FINAL
MY3 (2023) MONITORING REPORT

Response to Monitoring Year 3 (2023) DMS Comments

Shaw's Run Mitigation Site

DMS Project ID No. 100055, Contract # 7515

Site	Shaw's Run
Watershed:	Lumber River Basin, 03040203
XSID	UT2, XS - 11, Riffle
Feature	Riffle
Date:	5/24/2023
Field Crew:	Smith

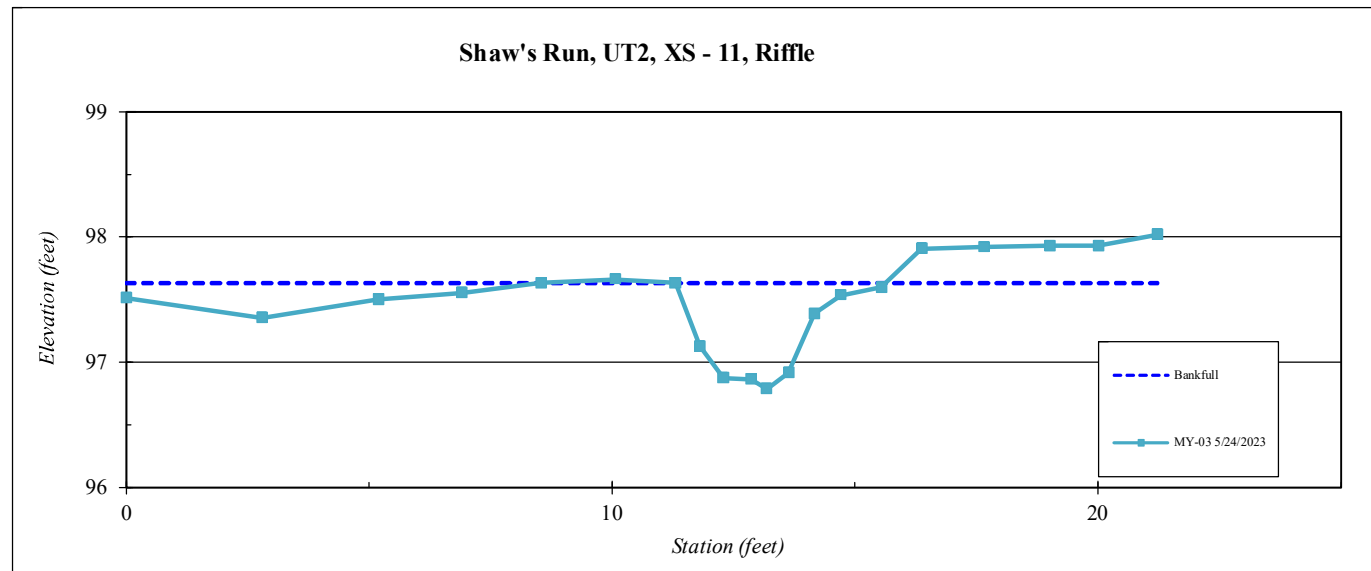
- Erin also noted that RS should add larger trees (one to three-gallon pots based on availability) in the areas of scalping along the easement edge.
- Todd requested adding a permanent monumented cross section on the upper reaches of UT2 to ensure the stream is not aggrading and will remain a single thread channel.

***Note: UT-2 XS-11 was added for the first time in MY-03 (2023) at the request of the IRT.

Shaws Run UT1 Upstream Year 3 (2023 Data)

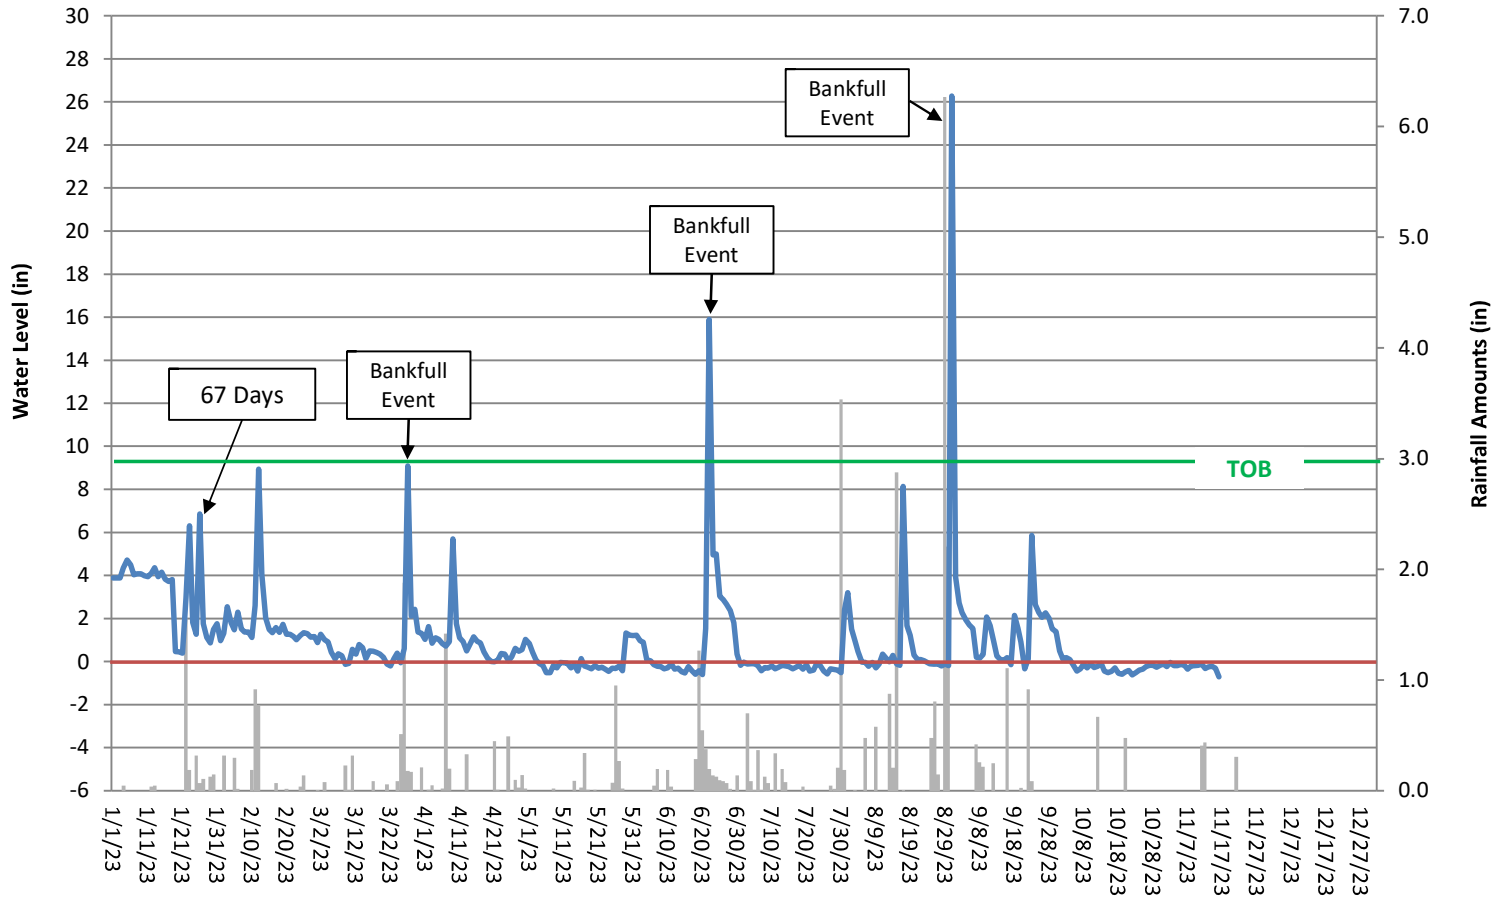
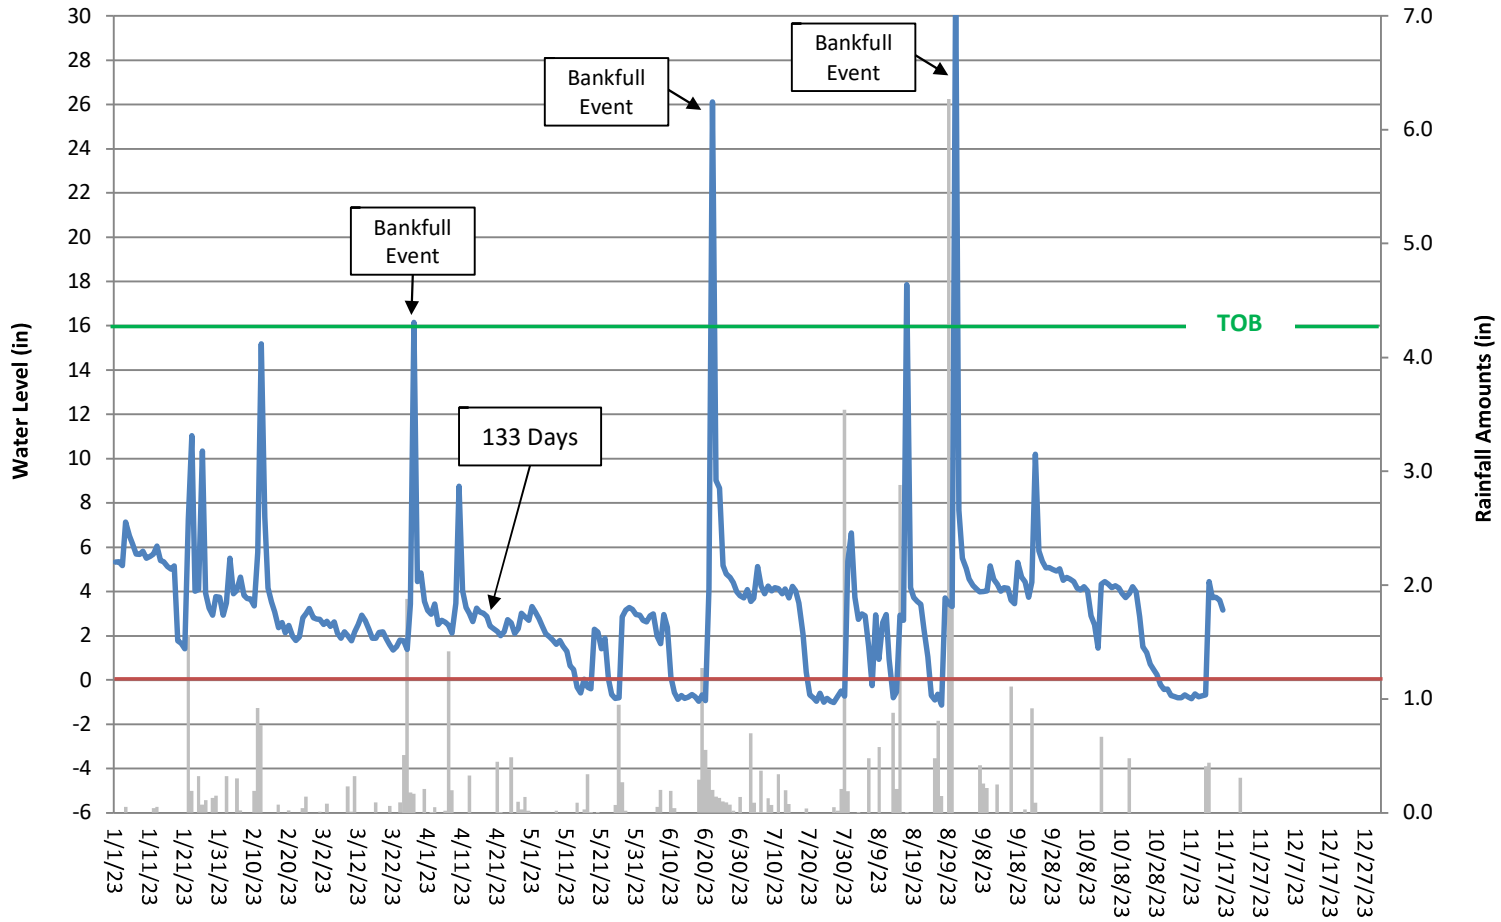
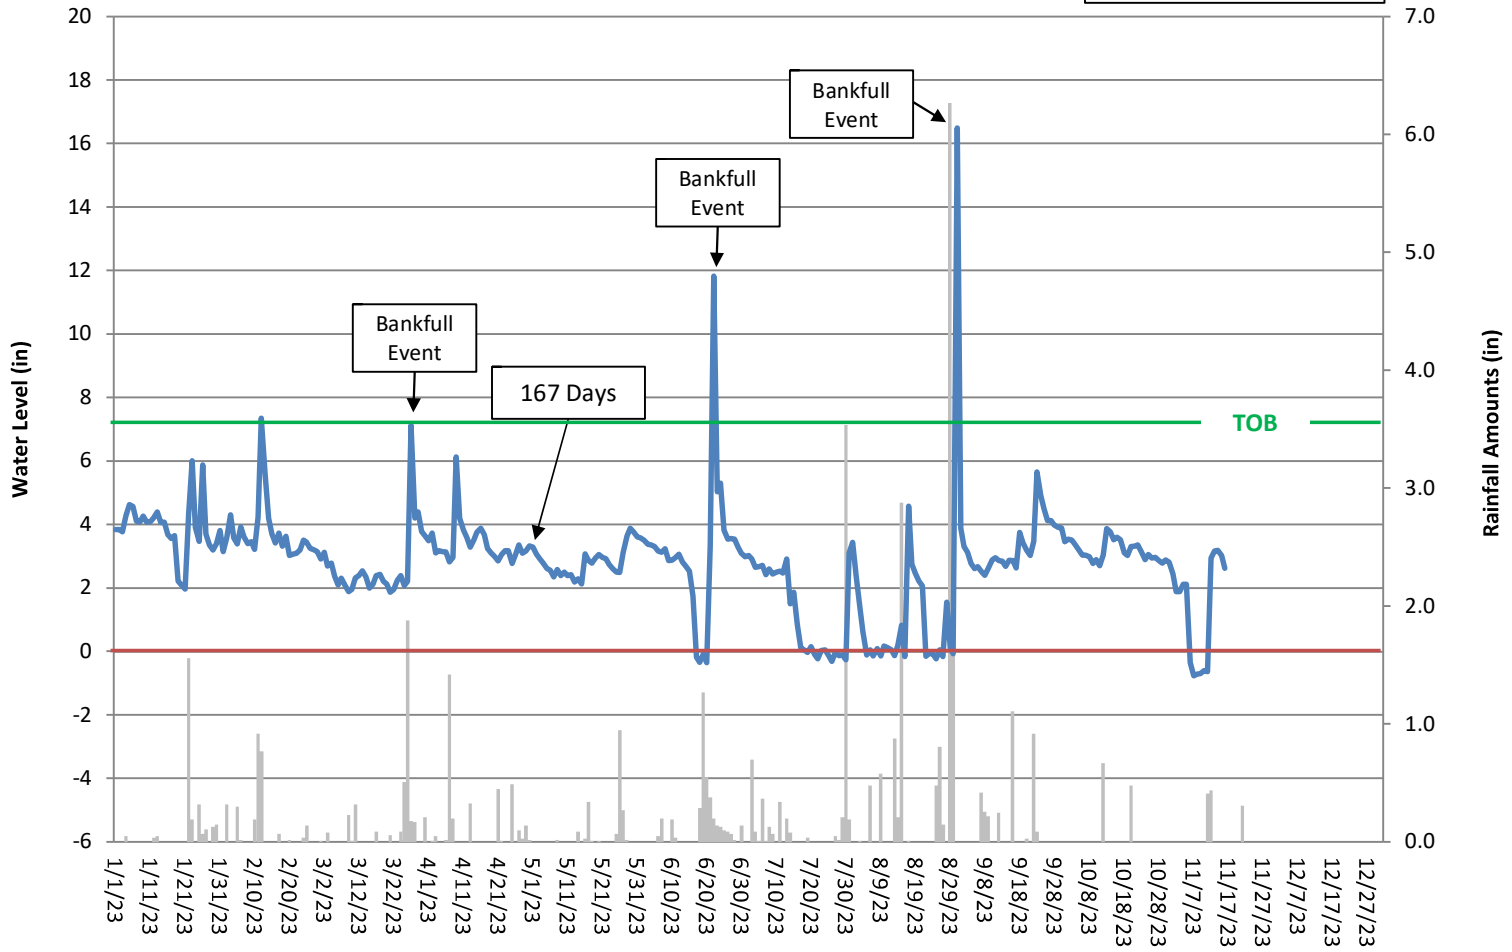
3. Appendix D, Surface Water Gauge Graphs: For clarity, please include a line on the graphs where bankfull is located for each gauge.
The surface water gauge graphs have been updated with the bankfull elevation.

Figure D1: Shaw's Run 30-70 Percentile Graph for Rainfall

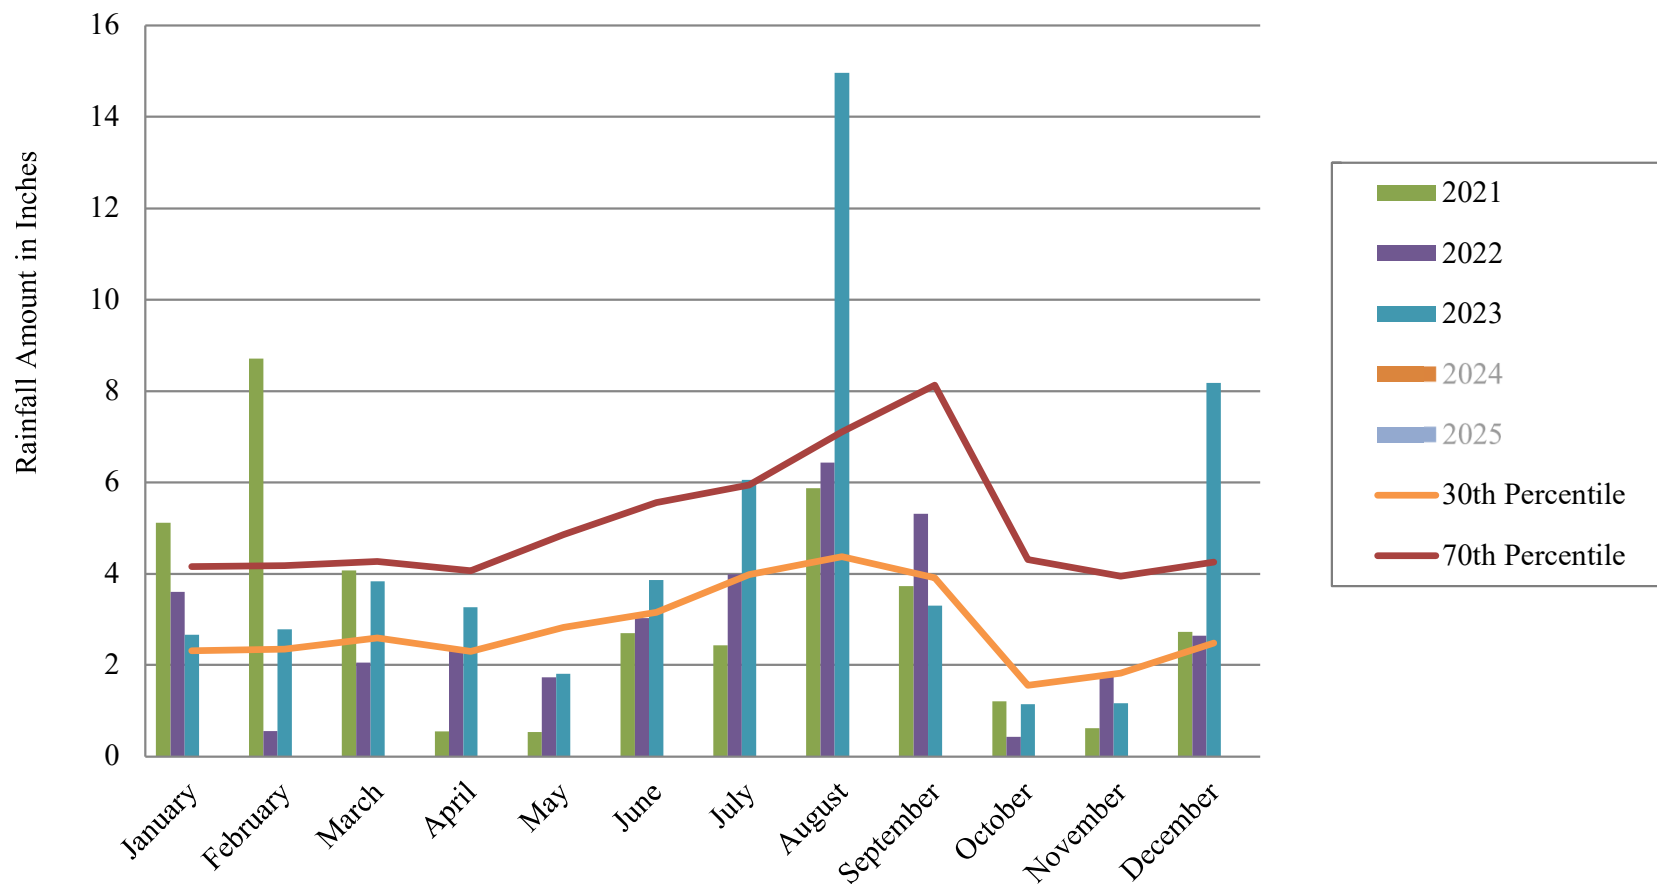
4. Appendix D, Figure D1 Rainfall: Please update rainfall data through December.
Figure D1 Rainfall has been updated to reflect rainfall through December. An additional site visit was not made in December, so data came from the closest Weather Underground station to the Site. December rainfall will be updated with onsite gauge data in MY4 when the rainfall gauge is downloaded.
